**3-11 WARD ST, NORTH SYDNEY  
ENVIRONMENTAL ASSESSMENT NORTH SYDNEY ZONE SUBSTATION**

**RE: MP 10\_0092 PART 3A EXHIBITION NORTH SYDNEY ZONE SUBSTATION**

We refer to the Part 3A exhibition of the Environmental Assessment for the North Sydney Zone Substation at 3 -11 Ward St North Sydney.

Figure 3.3.2: Photomontage of view middle of Harnett Street (Source: Kann Finch Group). The lower portion of the horizontal banded metal area is a roller door, the upper portion are louvres for ventilation.

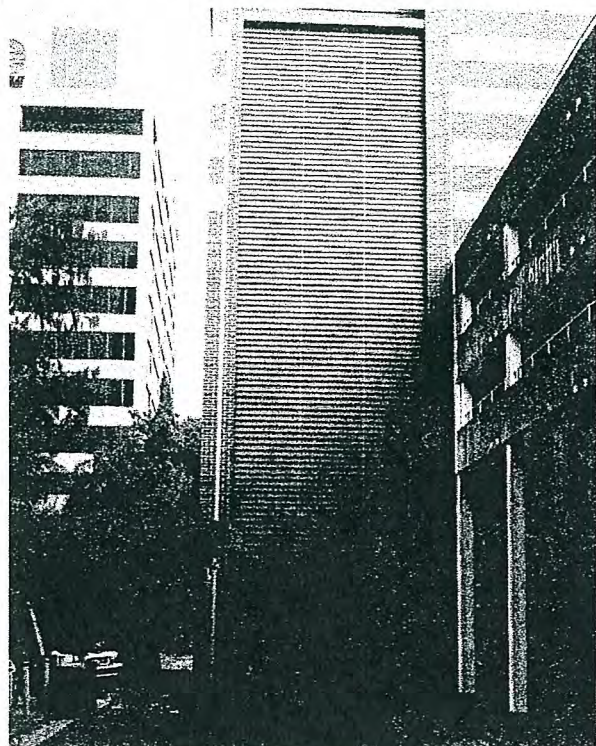
*The suggestion (see Observer Location 3 Table ES1.1) that landscaping in the approved 136 Walker St should provide a visual barrier is a transfer of responsibility for proper design. We understand Council has previously requested design improvement when Energy Australia self approved the previous approval, but no response to Council's concerns were made.*

Given the activities within the substation are likely to be carried out 24hours a day 365 days a year, then the two vertical louvers on the eastern elevation should be relocated from this adjacent elevation.
